Site / Mass Grading / Sediment Control Plans

Troy Hill Corporate Center

SDP-98-143

TROY HILL CORPORATE CENTER
 PHASE IIA
 TROY HILL DRIVE
 REVISED STORMWATER MANAGEMENT POND # 3

SEDIMENT BASIN #3
PLAN

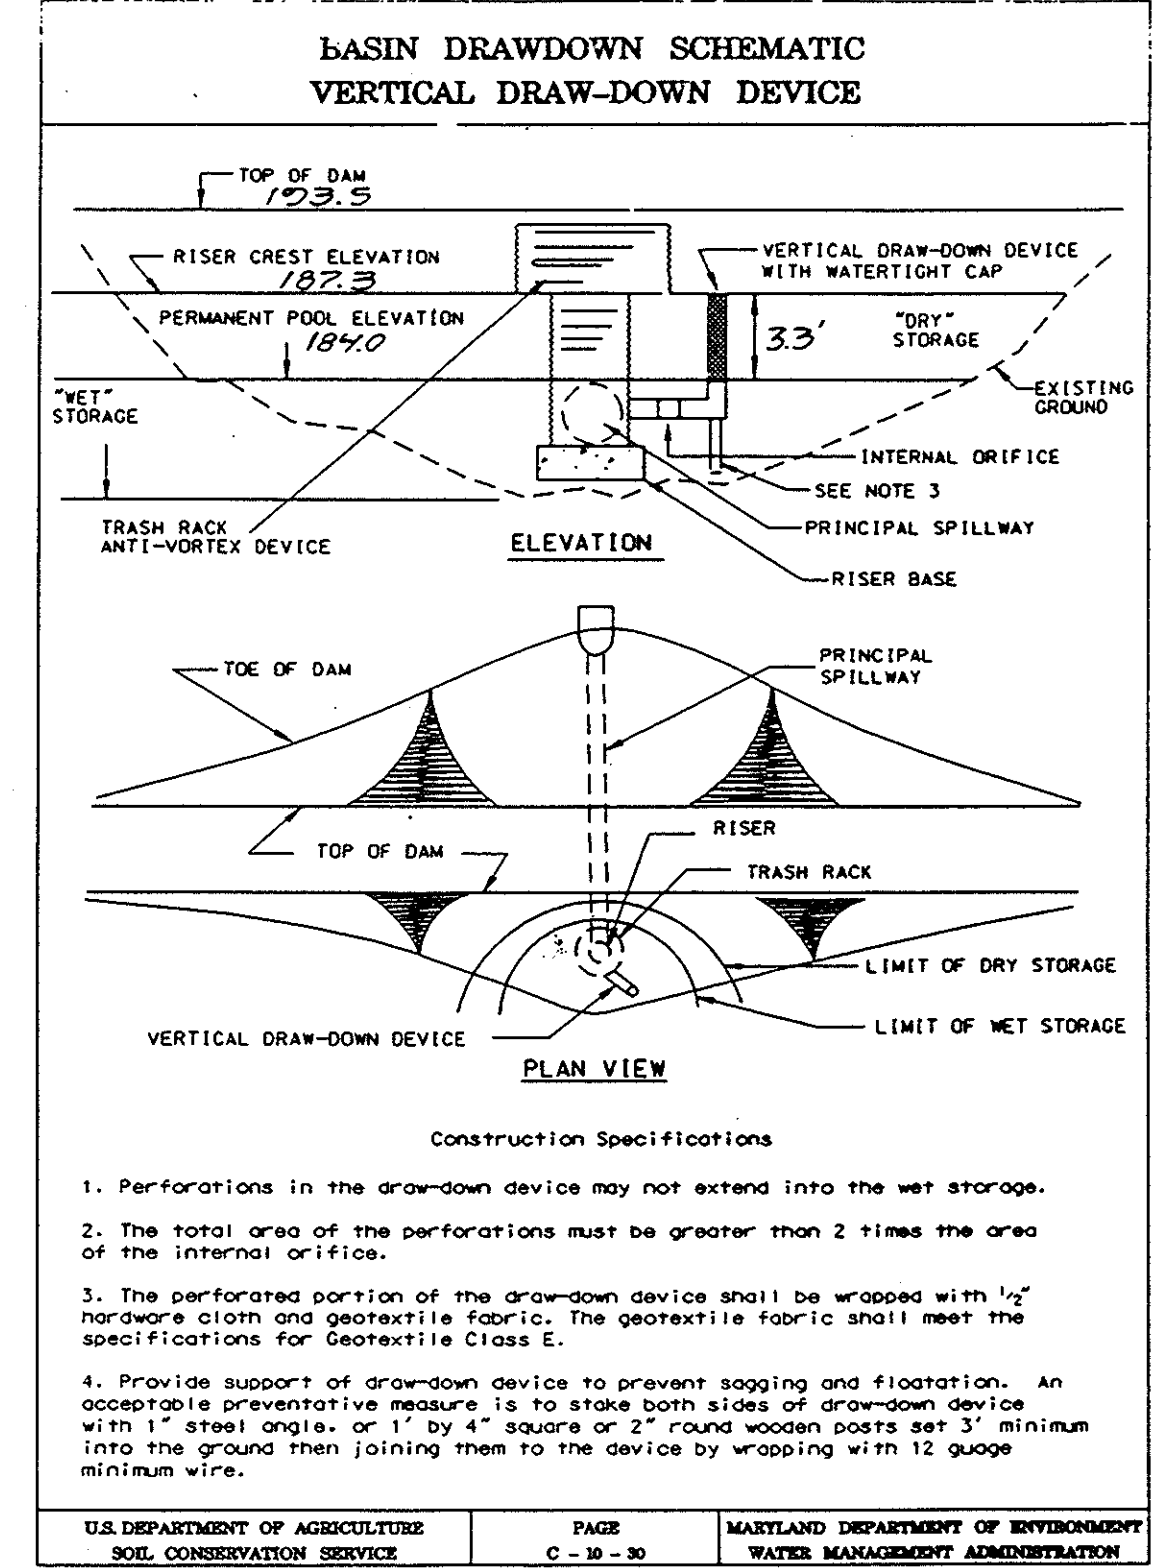
DESIGNED: KJ	BY: GWS	NO: 1	REVISION: REVISED ACCESS RAMP TO SEDIMENT BASIN NO. 3 AND REVISED PROPERTY LINES	DATE: 2/19/99
CHECKED: TC

SCALE: AS SHOWN
SHEET NO. 12 OF 13

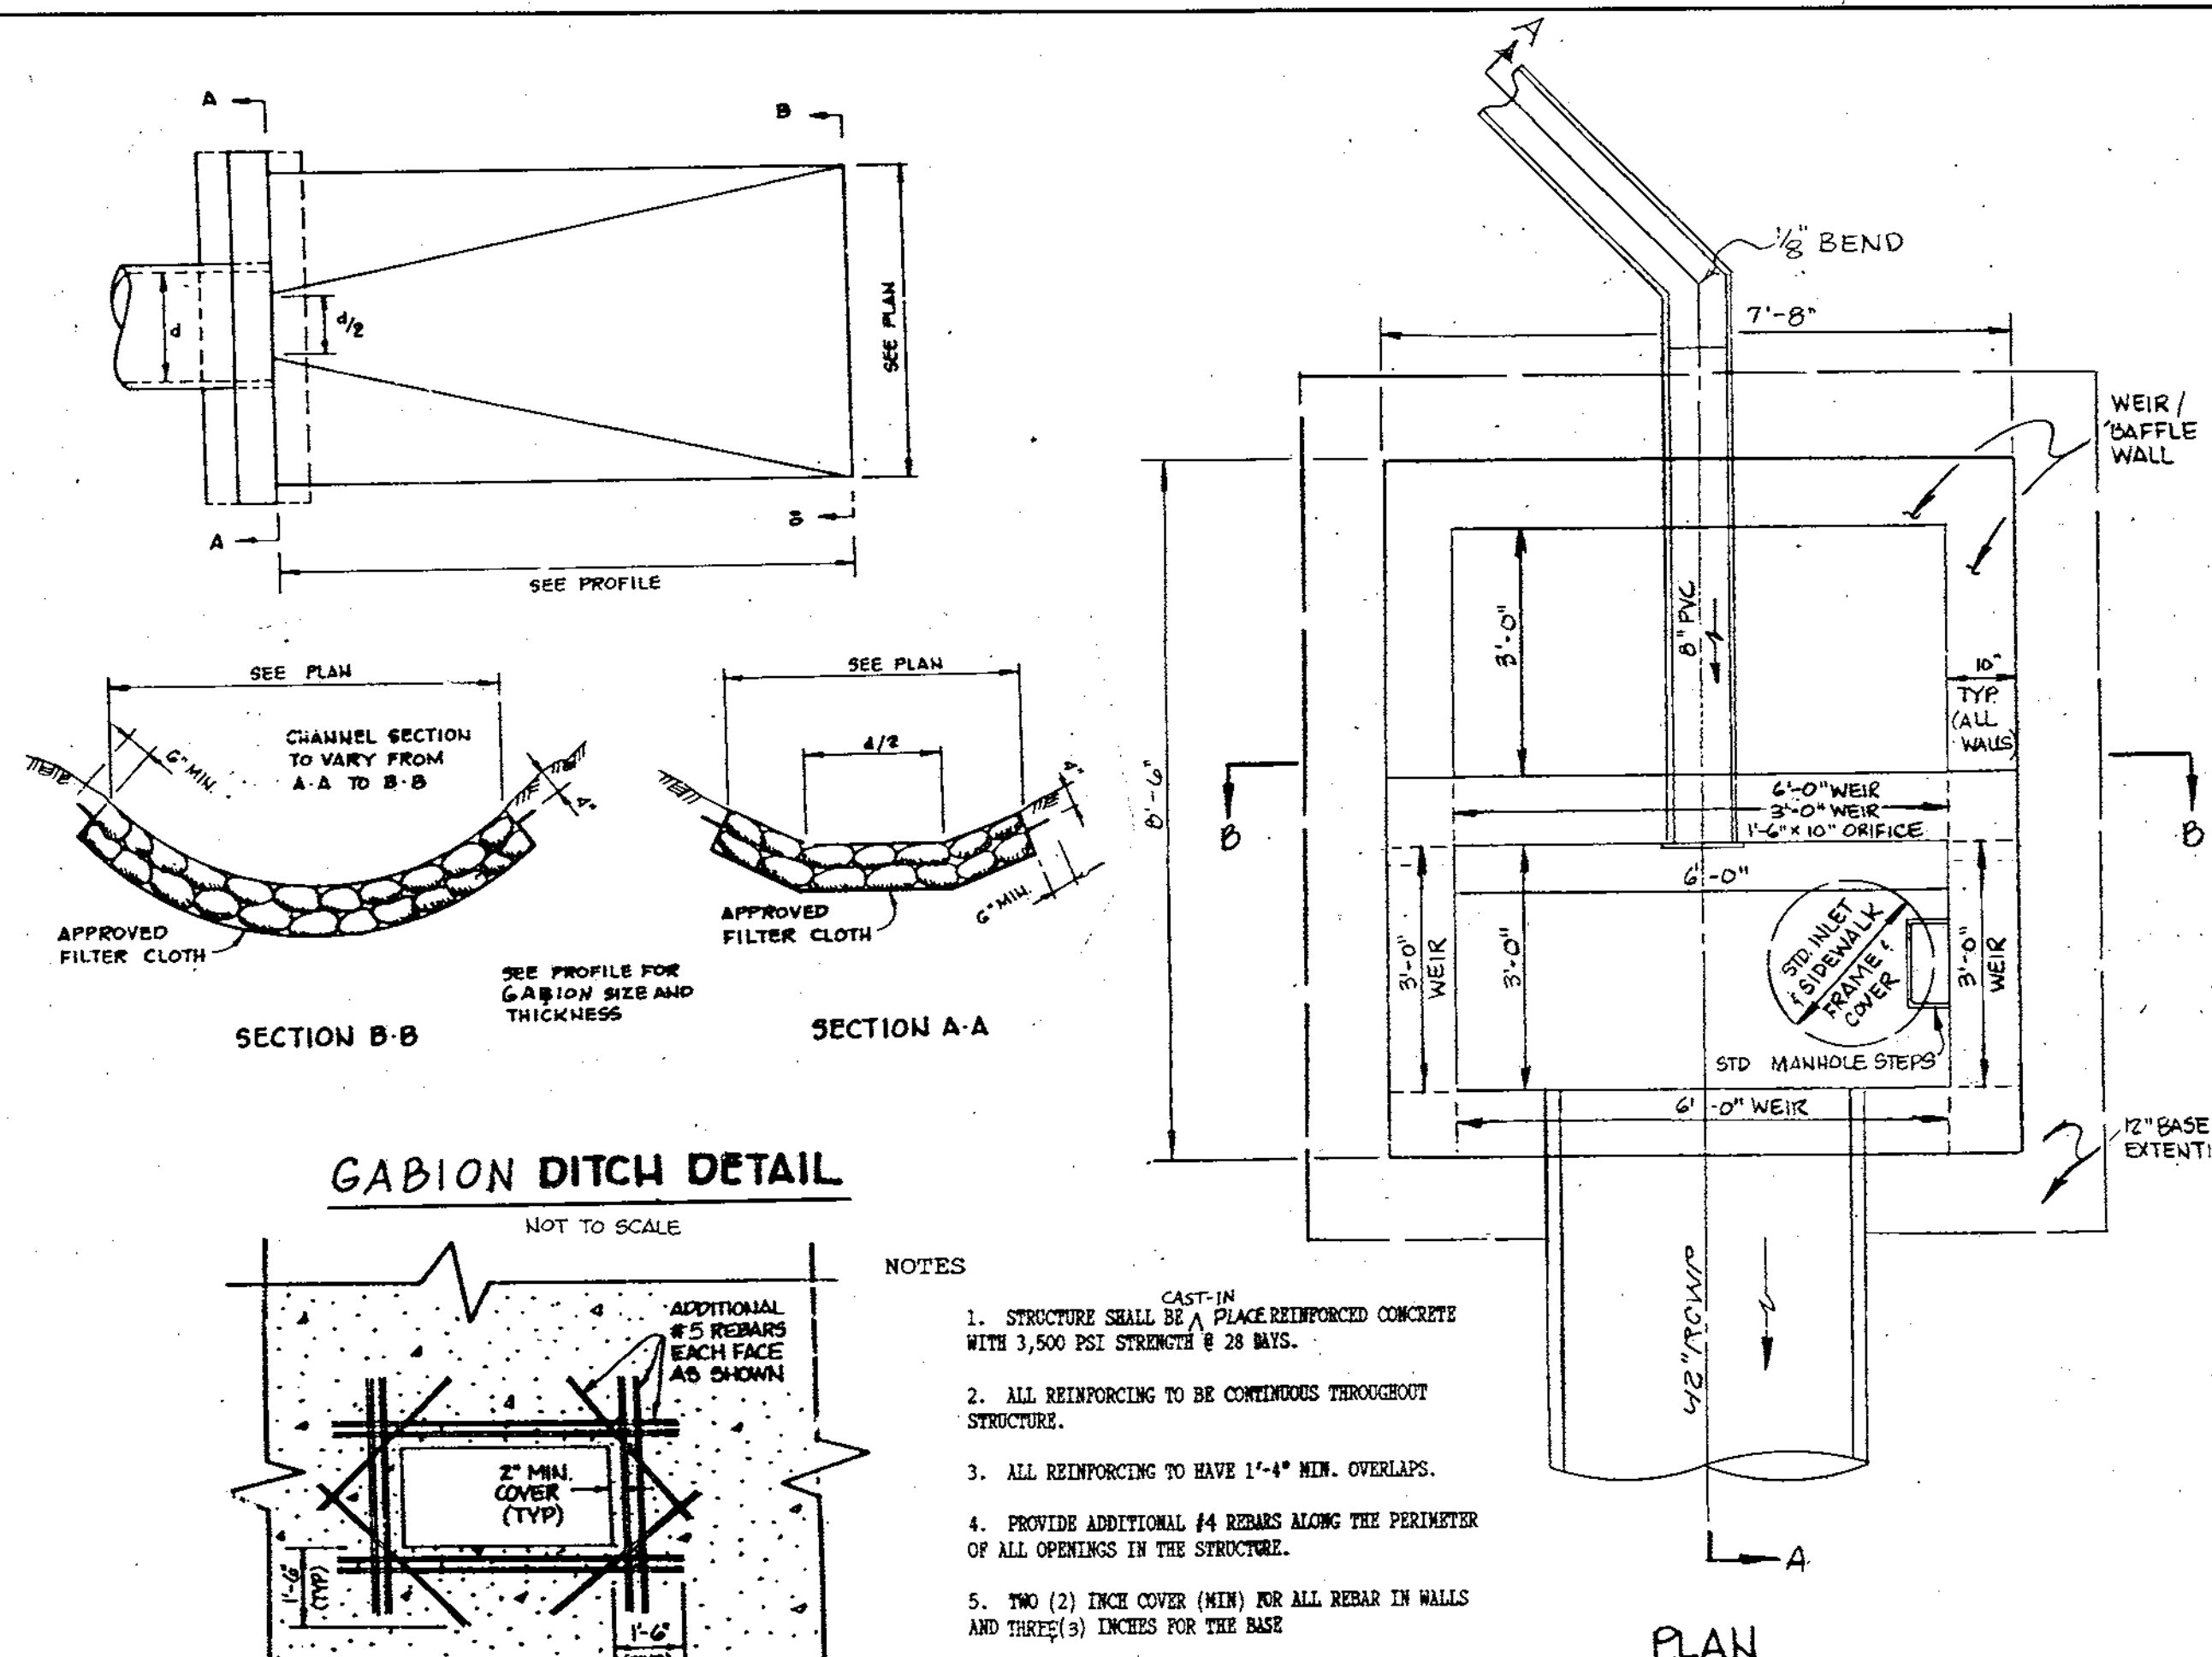
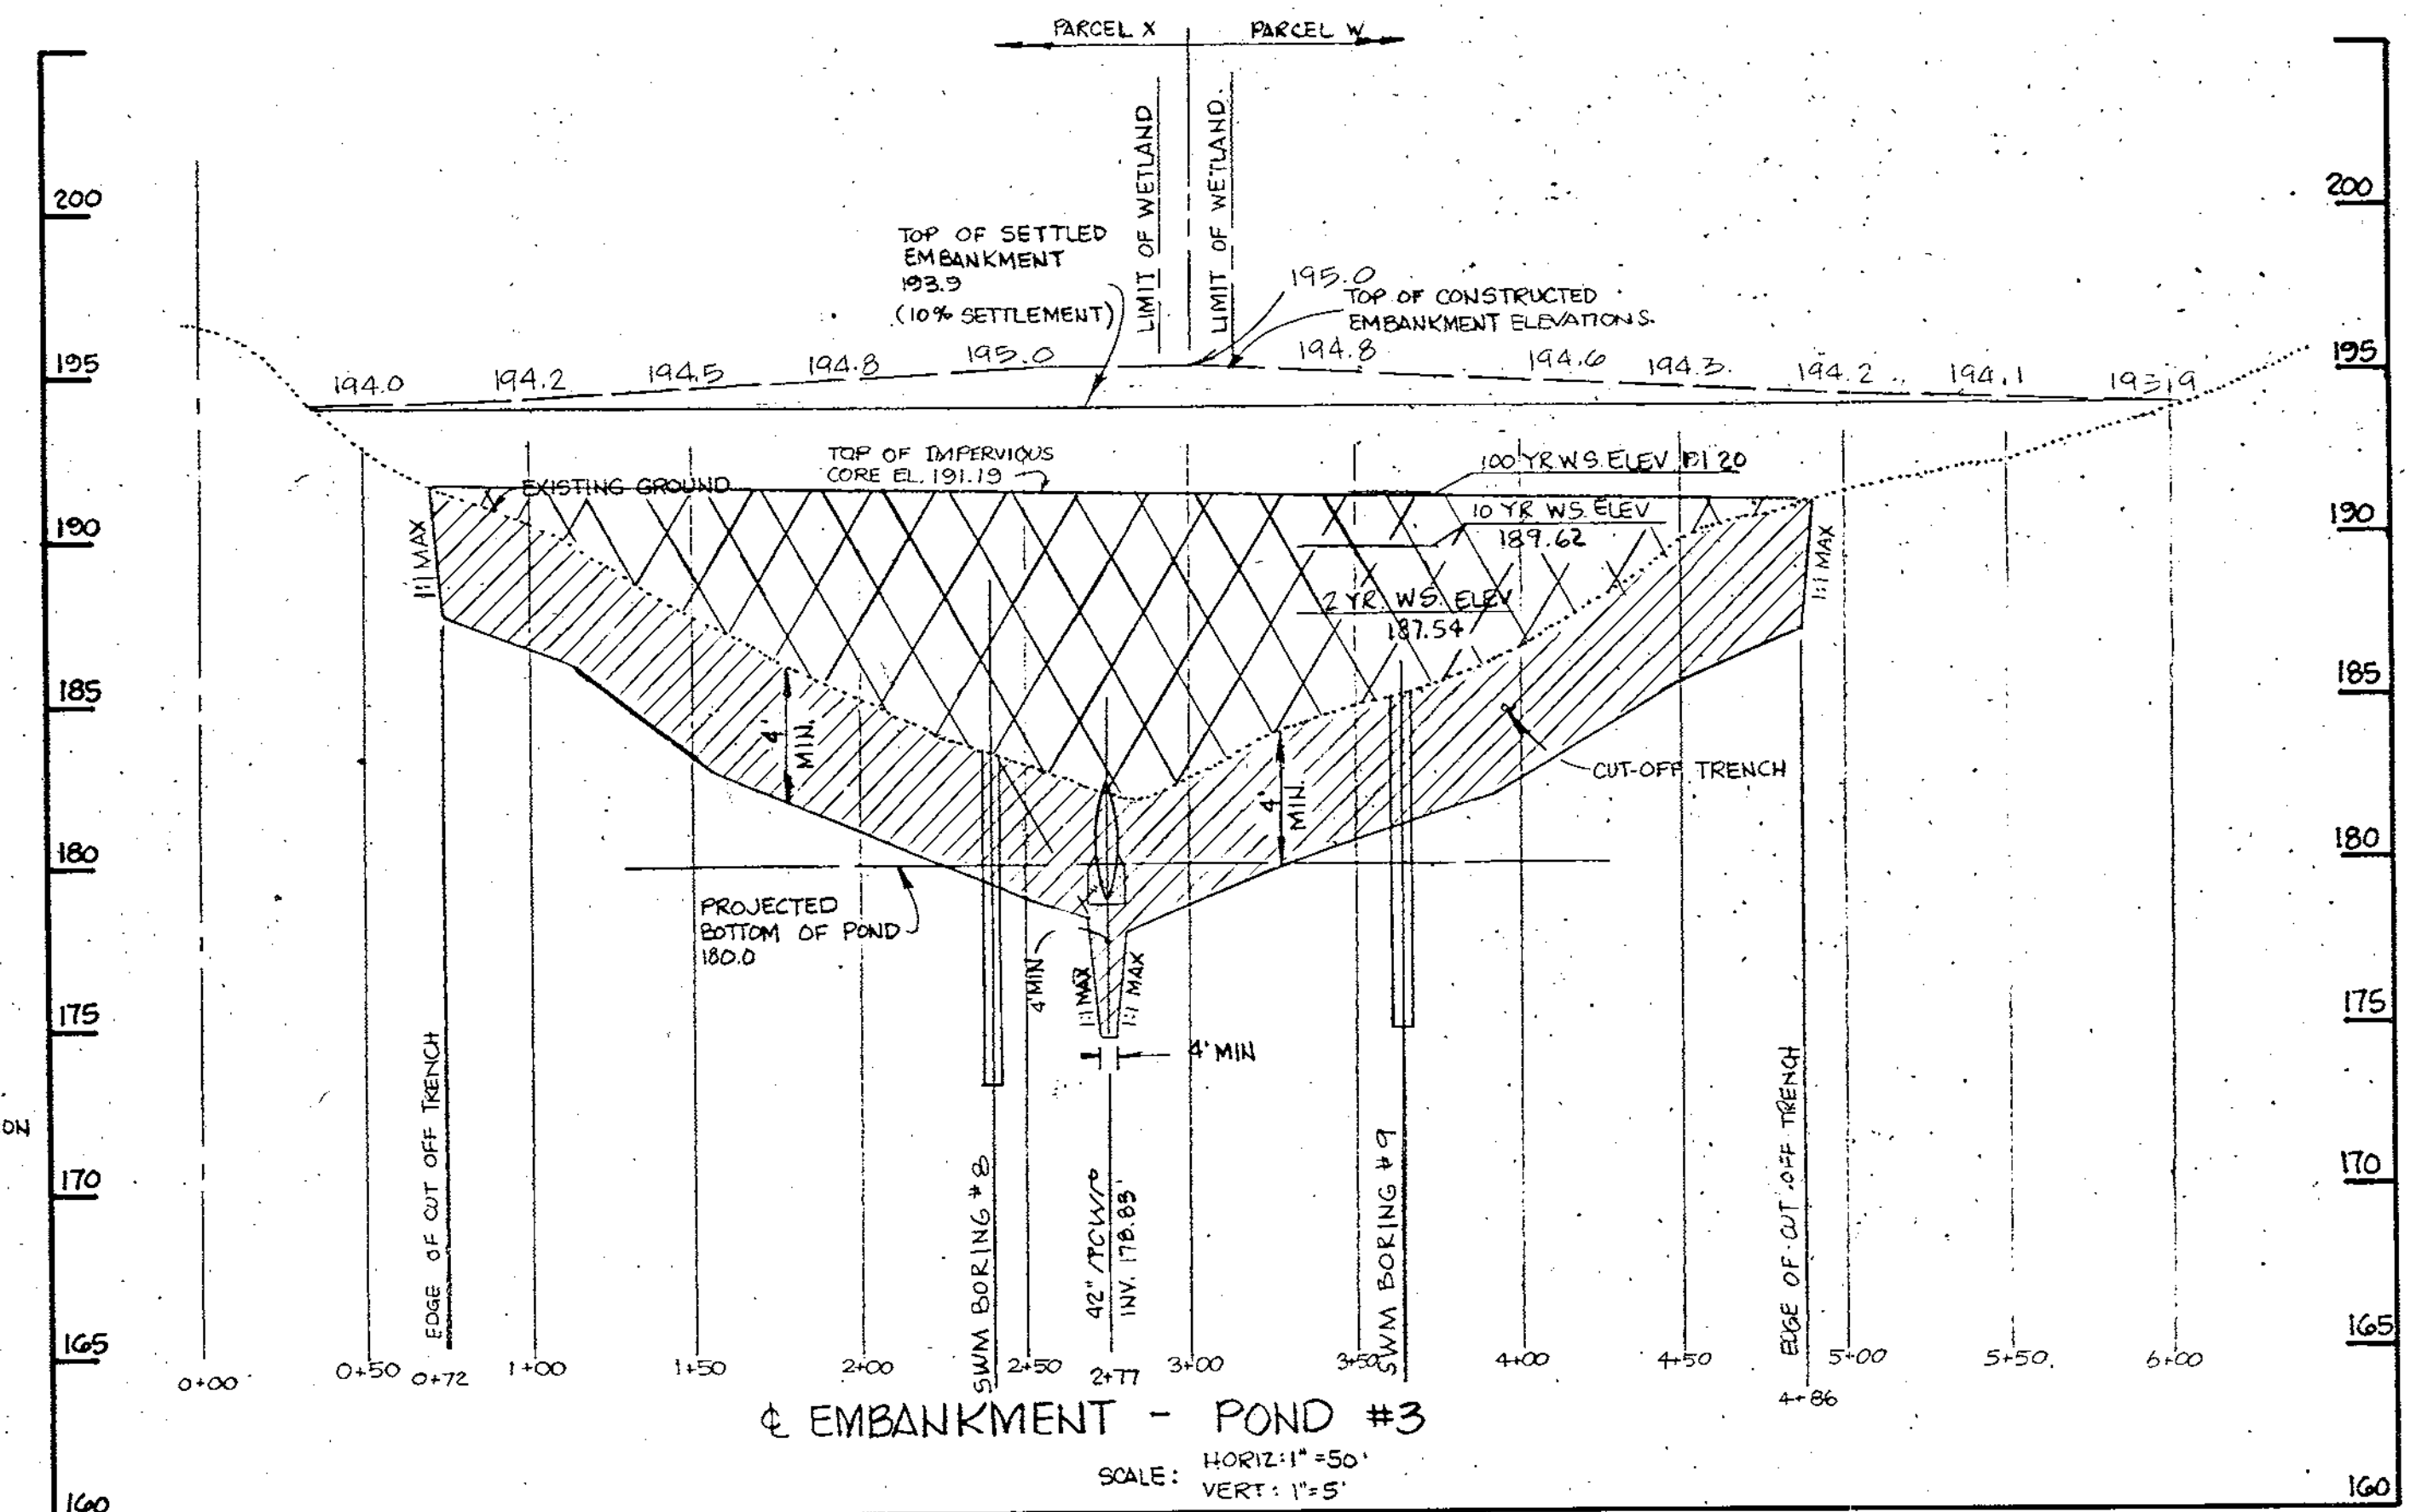
DESIGNED: KJ	BY: MRA	NO: 1	REVISION: REVISE ACCESS RAMP GRADES, MODIFY RISER, ELIMINATE LOW FLOW CHANNEL	DATE: 11/03/98
DRAWN: CDT	CHECKED: TC
